HINCKLEY NATIONAL RAIL FREIGHT INTERCHANGE

*Blaby District Council (IP ref.
20040018) Response to
Secretary of State on Application
by Tritax Symmetry (Hinckley) Ltd
for the proposed Hinckley
National Rail Freight Interchange
Project (TR050007)*

Deadline – February 07, 2025

**Figure 2.1: Light Vehicles Trip Distribution to and from the Hinckley NRFI Development Site
2026 'With Development' (AM) - To the Development**

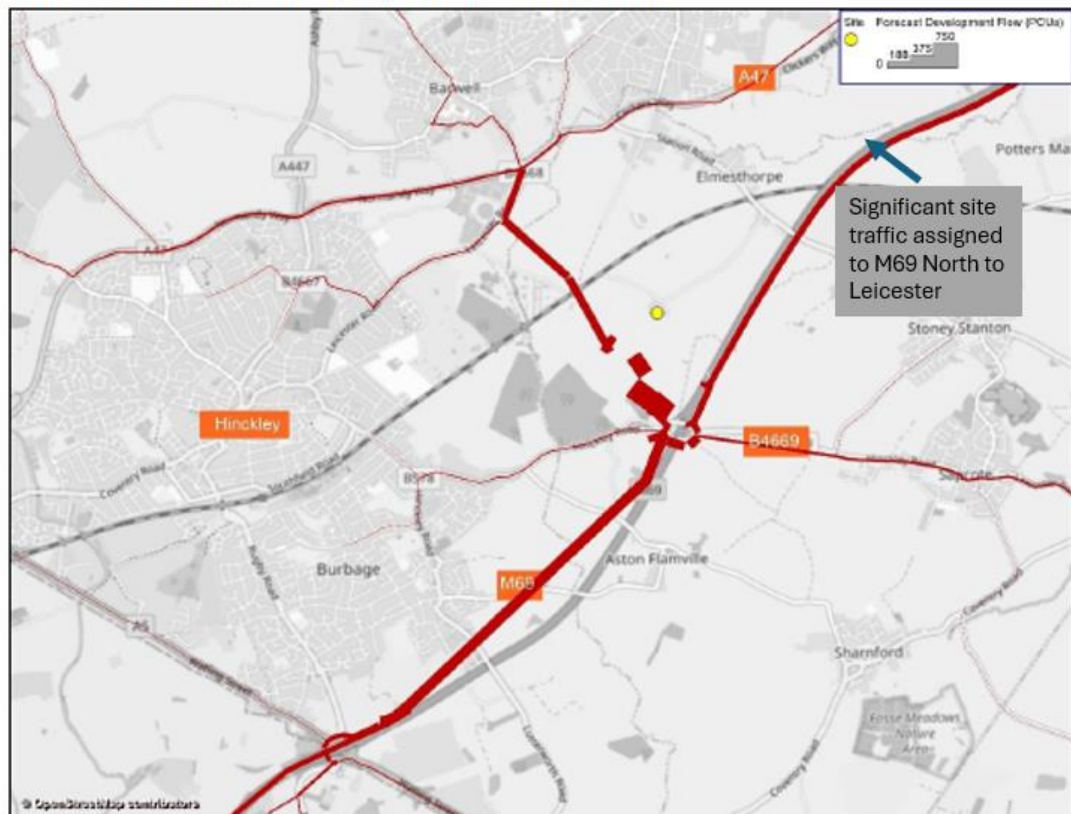
Figure 2.1 of this report (BDC note added) shows the distribution of traffic to the development in the am peak in 2026, clearly showing very high volumes of development traffic wishing to use the M69 from Leicester to the site (the corresponding figure for traffic travelling from the development shows a similar picture heading away to the north).

Figure 3.6: Forecast Flow Change for the 2026 and 2036 'With Development'

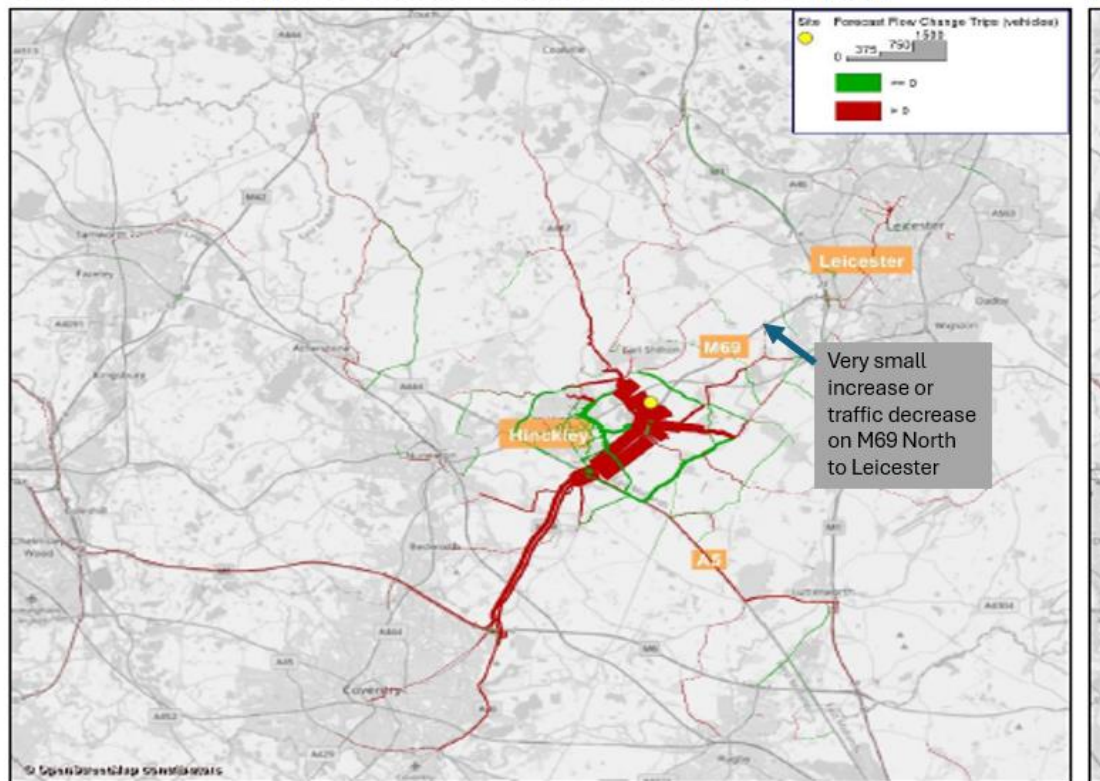
- 3.9. However Figure 3.6 shows the actual modelled traffic – there is a very small increase in one direction and a decrease in traffic on the M69 north post-development. This is because of the conditions at J21 and the Applicant's additional traffic, in effect every single vehicle added by the development pushes off the M69 an existing vehicle to less suitable local roads. This outcome is almost entirely due to the congestion at J21 of the M1. It is for this reason that BDC (and LCC) are insistent on the correct modelling of this junction so that the impact and knock-on impact and appropriate mitigation can be properly understood.

- 3.10. The M1 J21 Modelling Note submitted by the Applicant includes queue length validation for the M69 approach to the junction suggesting a length of 140m in the pm peak. This demonstrates the inadequacies of using the LinSig model as the true queue length is a matter of kilometers, something the ExA experienced themselves directly. BDC acknowledges and endorses the LCC estimate that as LinSig only assess traffic reaching a stop line it does not reflect the free flow links at J21 and thses missing numbers account for an estimated 3-4,000 cars in the peak period. This is far too significant to be overlooked by the Secretary of State.

GENERAL ARRANGEMENT, Appendix 2C of applicant technical note issued to SoS 12/12/24

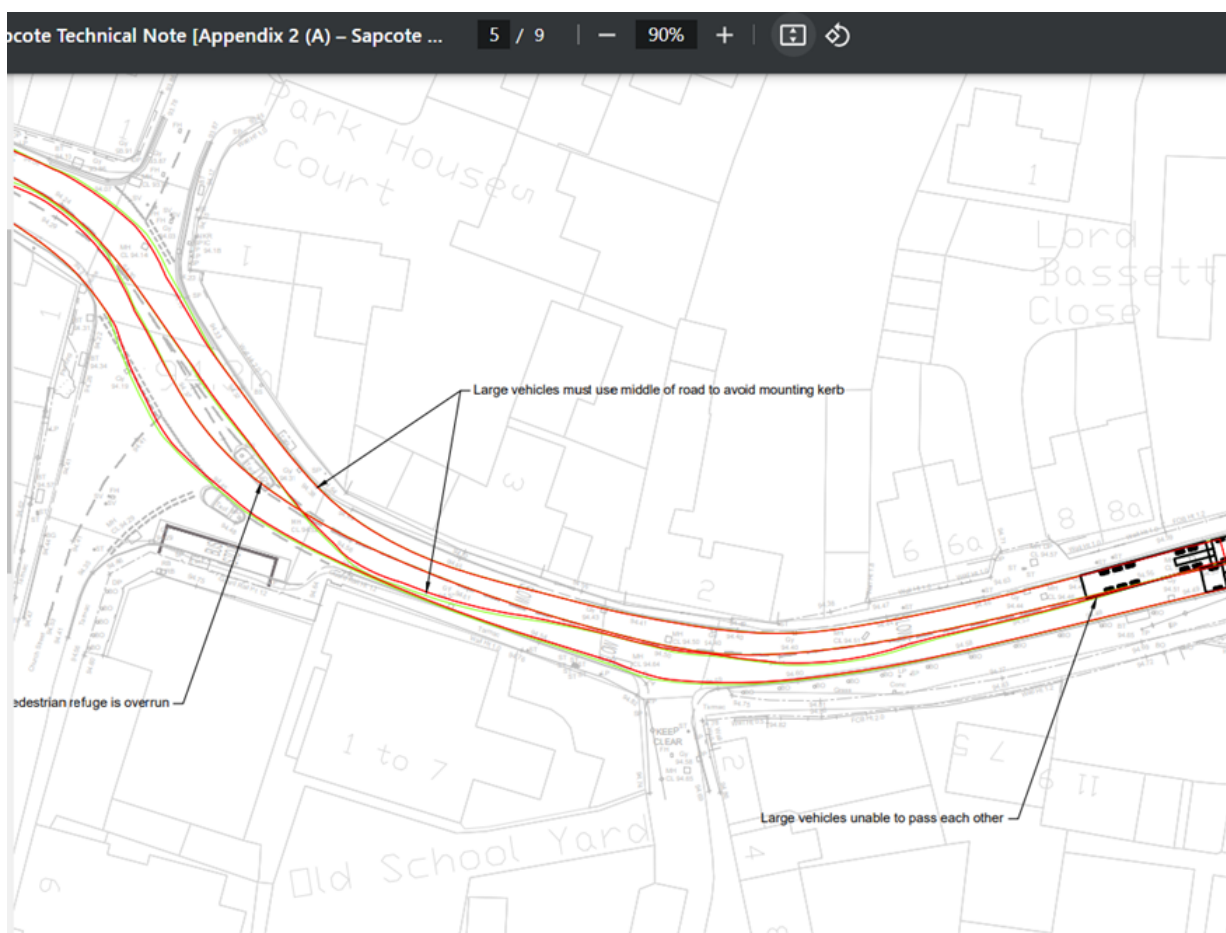
- 5.9. Further, the proposed revised design by the Applicant retains a carriageway of 4.8m in the centre of the village⁴, which BDC believes will raise further safety issues when a HGV passes a car as well as when two HGV's pass each other. The standard maximum width of a HGV body is 2.55m under UK law, some popular HGVs can be 5cm narrower. Actual loads carried can be wider, up to 2.9m without been classified as an abnormal load with special signing etc. thus creating increased risk of collisions.

- 5.10. With extended wing mirrors (mandatory for large vehicles, but at a minimum height of 2m) the overall width increases by 20-30cm on each side. The width of a medium car such as a Ford Focus is 1.979m with mirrors unfolded. Ignoring the HGV mirrors (although only some cars will seek to pass so close as to ignore them), and ignoring any legal load widths above 2.55m, a DAF XF of 2.49m passing a medium car in this constrained 4.8m stretch of road would require 4.5m, without allowing for any gap between the vehicles or to the kerbs. It is obvious that the 4.8m is barely adequate on a completely straight section of road, and perfect vehicle alignment, passing a medium rather than large car. This stretch of road is straight for a short section but has curves on the approach and exit so vehicle behaviour will increase the width needed. With these dimensions it is BDC's view that it is highly likely that the increased volumes of HGV's passing a car will create increased risks of overrunning the footways.
